ADDENDUM 03, DELTA 03 DATE 05.01.2026

PROJECT: Santa Rosa Freestanding Emergency Room

ARCHITECT'S PROJECT NUMBER:
225014.00

OWNER: HCA Florida Fort Walton-Destin Hospital

1 NURSE CALL - FLOOR PLAN
SCALE: 1/8" = 1'-0"

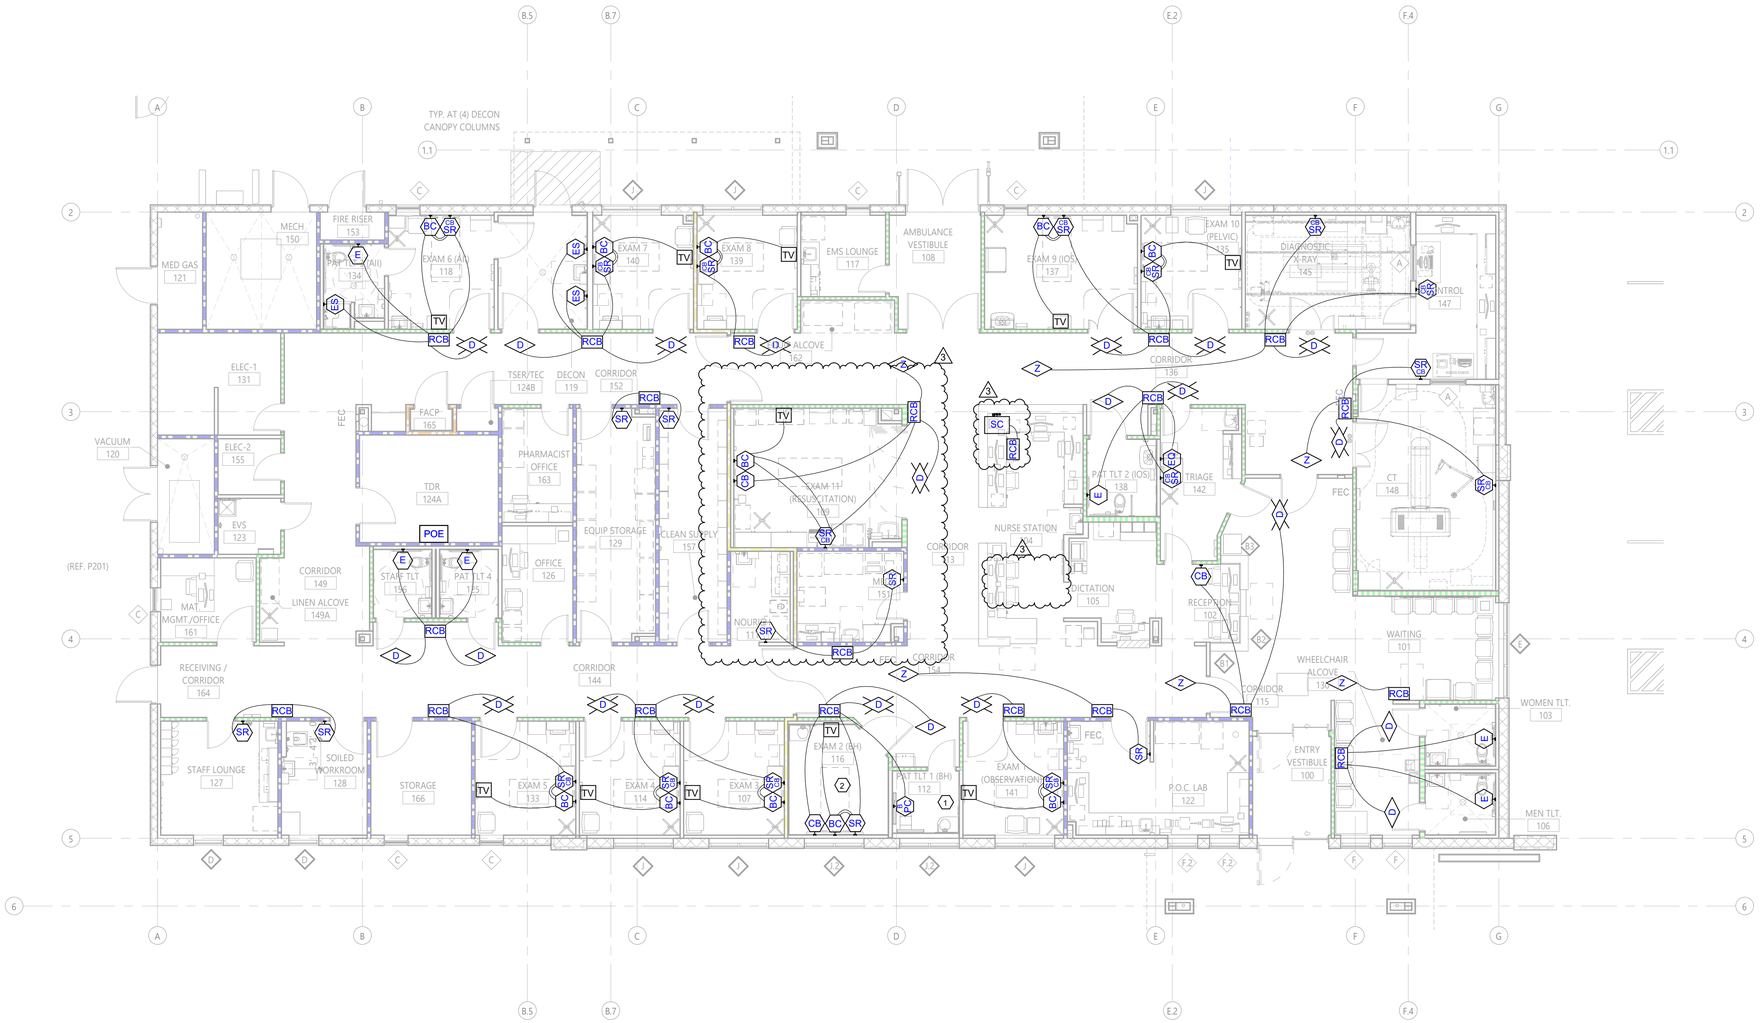
1. Revised nurse call devices to match architectural floor plan changes in the resuscitation, nourish, and meds room.
